# Planning Commission Agenda

**July 10, 2025**

<b>SUBJECT:</b> Public Hearing - Review and action on a request by Kathleen Ford with Quail Pointe Veterinary Clinic for Site Plan approval on 1.24 acres located at 868 North 2000 West (Parcel No. 14-062-0037).	<b>AGENDA ITEM:</b>  <div style="text-align: center; font-size: 2em; font-weight: bold;">1</div>
<b>PETITIONER:</b> Kathleen Ford – Quail Pointe Veterinary Clinic <b>SUBMITTED BY:</b> Keaton Jones, Community Development	<b>MEETING DATE:</b> July 10, 2025
<b>ORDINANCE REFERENCES:</b> Zoning Ordinance (Title 28), Chapter 3 Site Plan Review, Chapter 4 Parking, Chapter 19 Performance Standard Zone.	<b>ROLL CALL VOTE:</b>  <div style="text-align: center; font-weight: bold;">YES</div>
<b>RECOMMENDATION:</b> Move to approve the request by Kathleen Ford with Quail Pointe Veterinary Clinic for Site Plan approval on 1.24 acres located at 868 North 2000 West.	
<b>BACKGROUND:</b> <ol style="list-style-type: none"> <li>1) The request consists of site plan approval for an addition to the East side of the existing veterinary clinic building as well as finishing the unimproved remainder of the site located at 868 North 2000 West (See <a href=

A1 ELECTRICAL PHOTOMETRIC SITE PLAN  
1/16" = 1'-0"

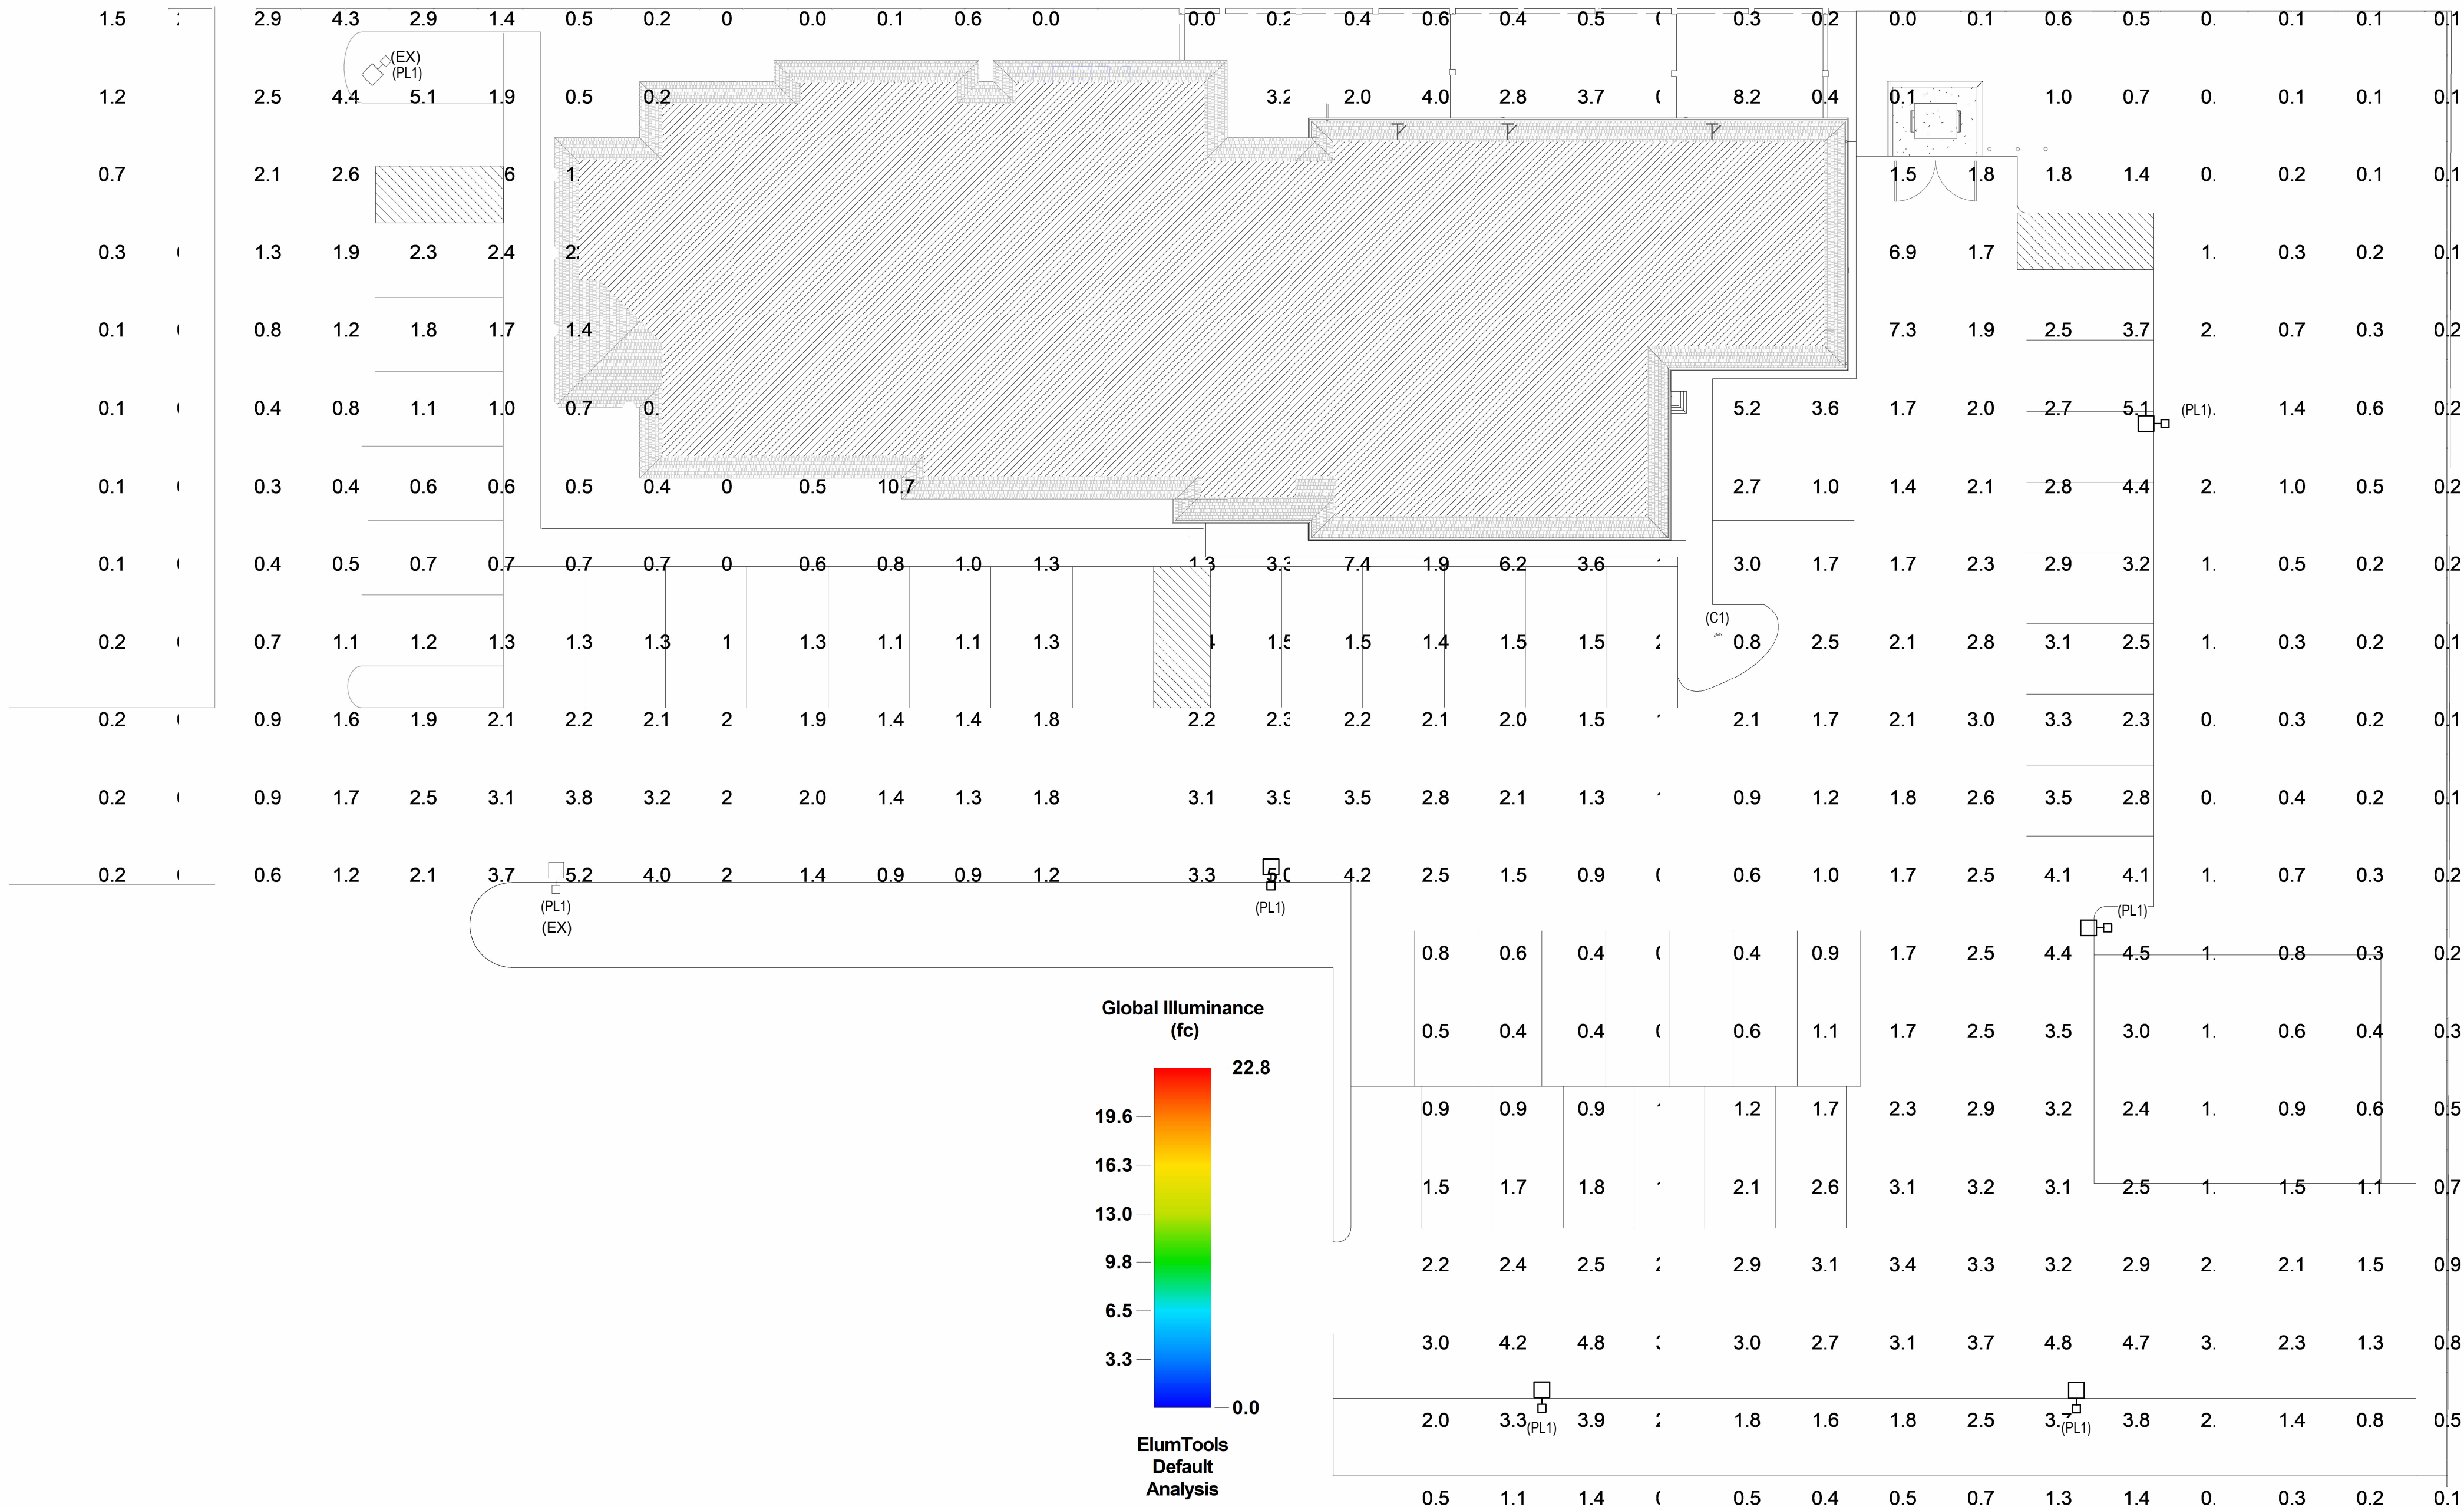
Based on the information provided above and the supporting attachments, the Planning Commission can make the finding that the site plan meets the general purpose and spirit of the PZ Zone (Performance Standard Zone) subject to submittal and approval of an updated photometric plan.

Landscape  
Site Plan

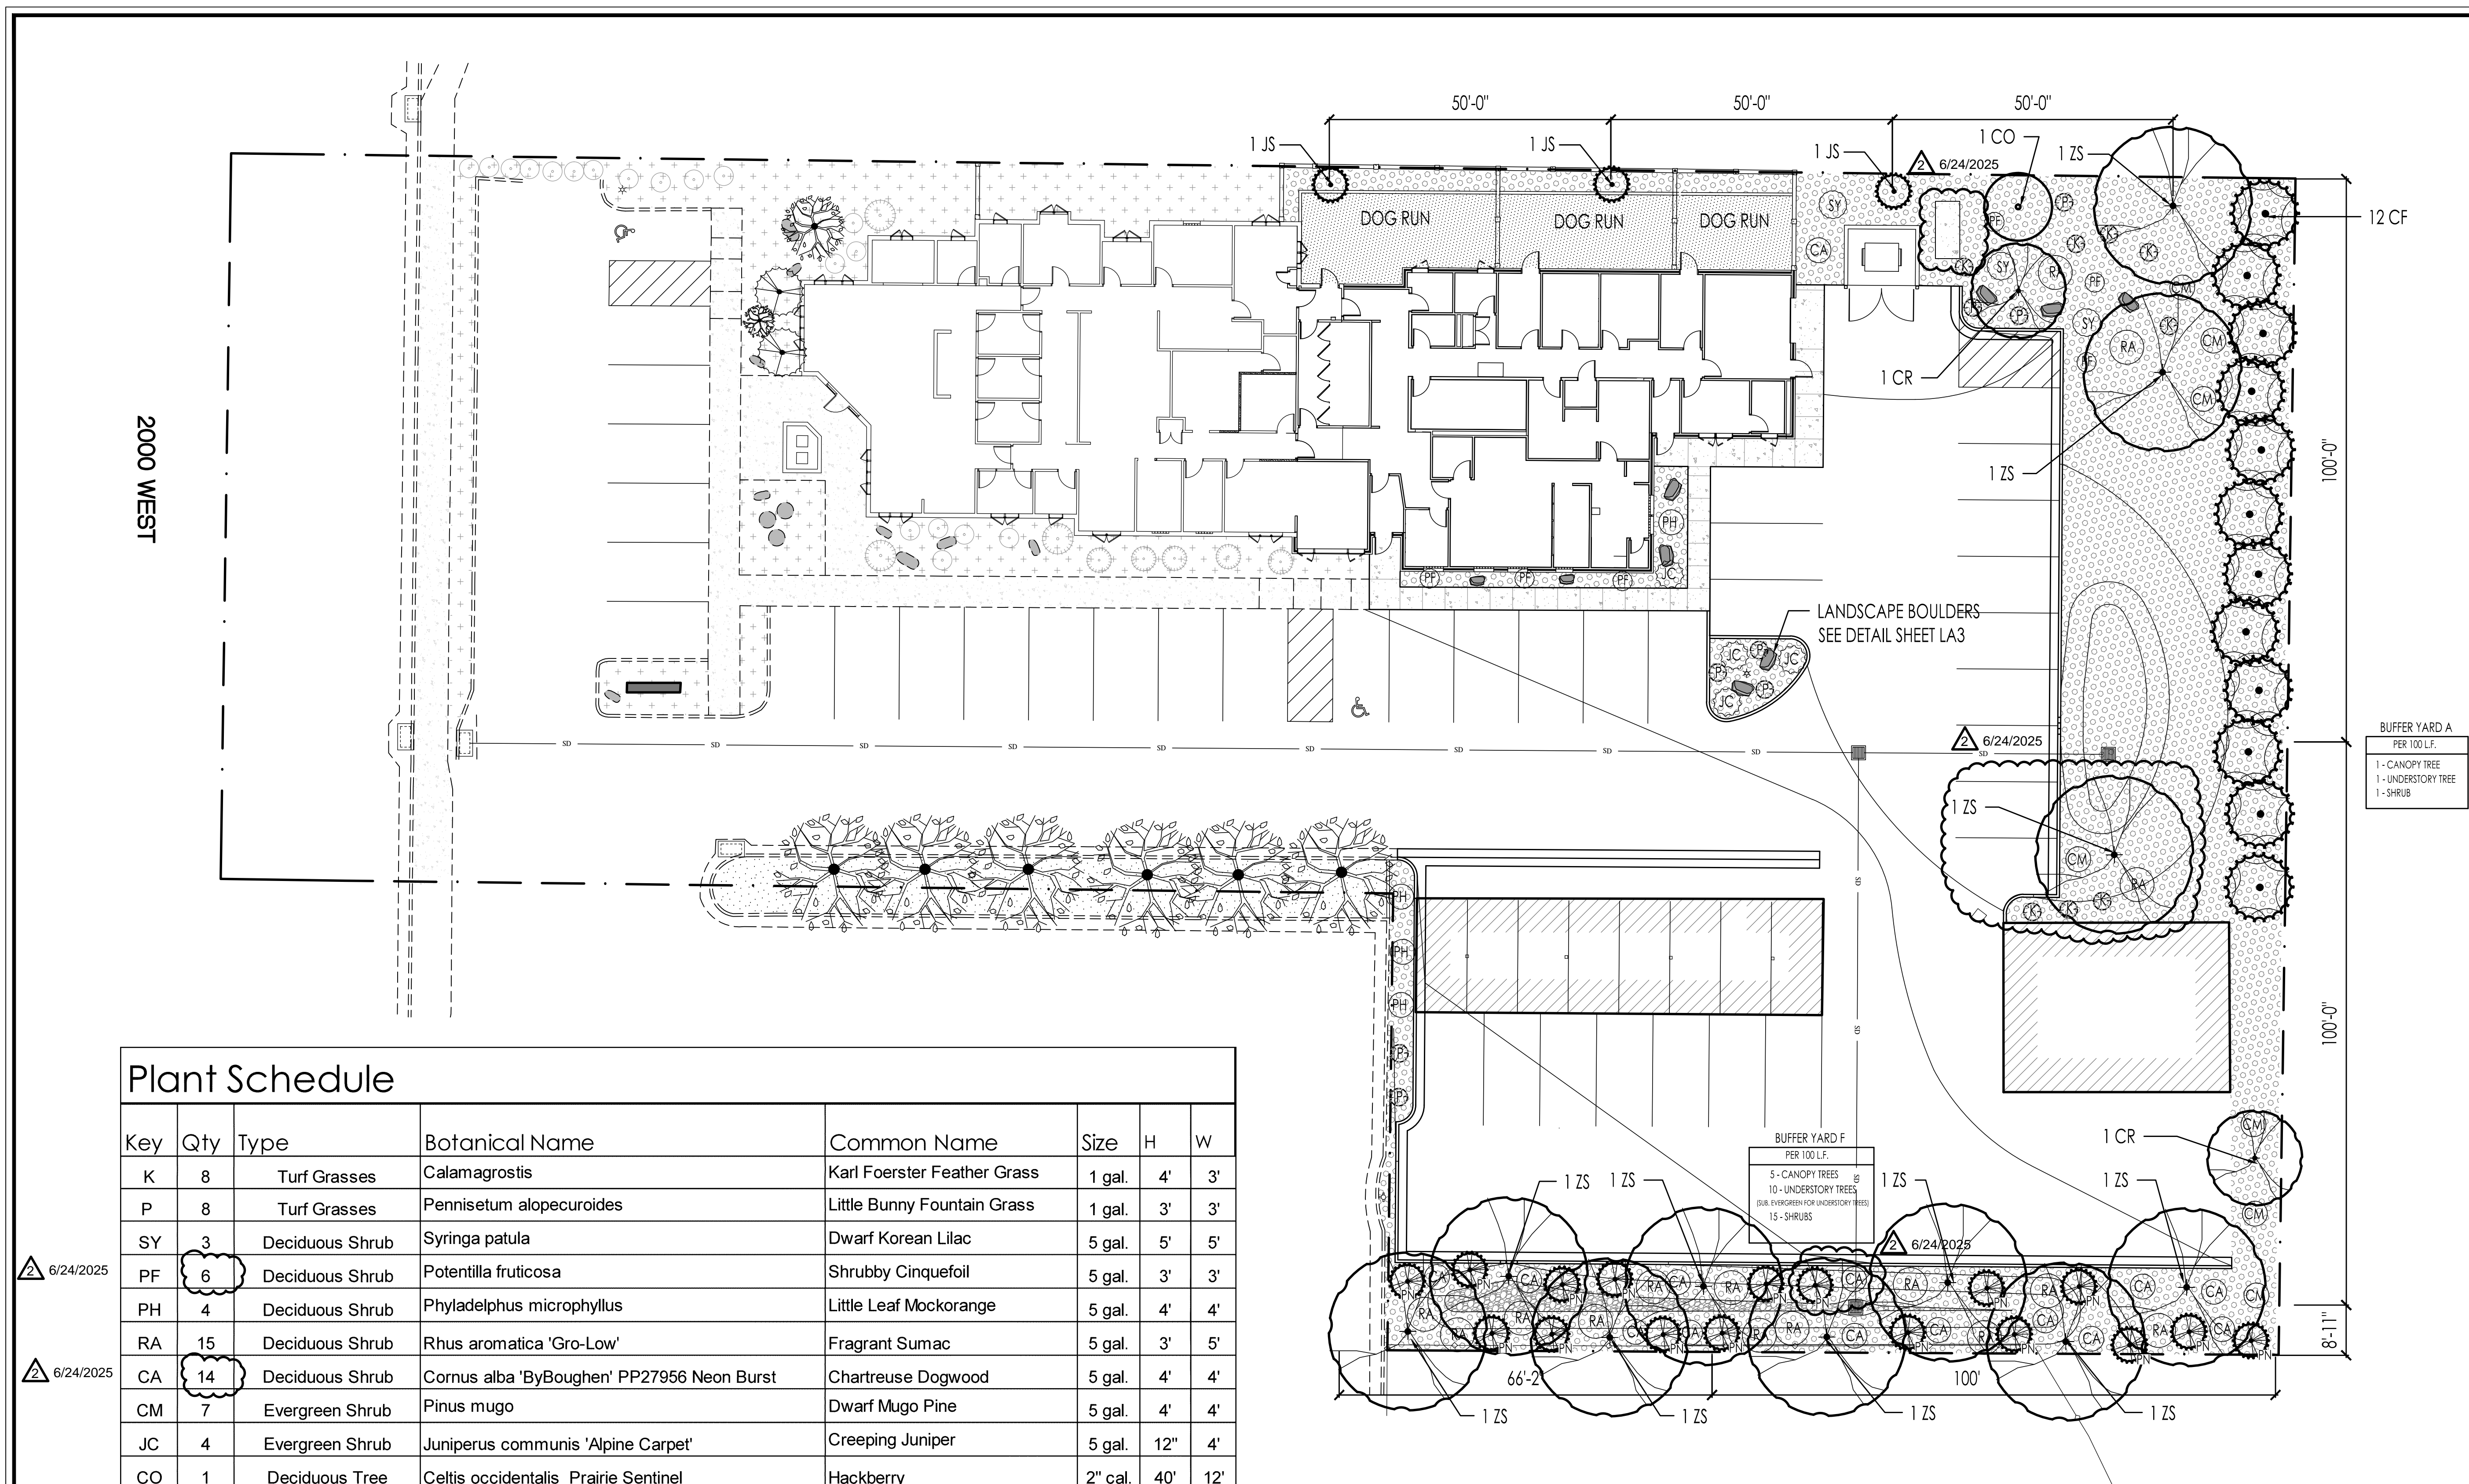
- 6) The landscape plan ([Attachment E](#)) is consistent with the guidelines of the water efficient landscape standards for new commercial developments. The landscape buffer yards on the North and East requires a buffer yard A, which requires a minimum of 1 canopy, 1 understory tree, and 1 shrub per 100 lineal feet. The East buffer includes a dozen evergreen trees, a couple canopy trees, an understory tree, and several shrubs. The North buffer includes a combination of evergreen trees, a canopy tree, a deciduous tree, an understory tree, and shrubs. New landscape rock mulch will surround the plantings throughout all the buffers.

The South buffer requires a buffer yard F, which requires 5 canopy trees, 10 understory trees, and 15 shrubs per 100 lineal feet. The south buffer yard against the residence shows a 15-foot-wide buffer yard that includes a combination of zelkova canopy trees, columnar Austrian pine understory trees, and various deciduous shrubs. There is an existing solid vinyl fence along this property line as well that satisfies the fence requirement for the buffer yard F.
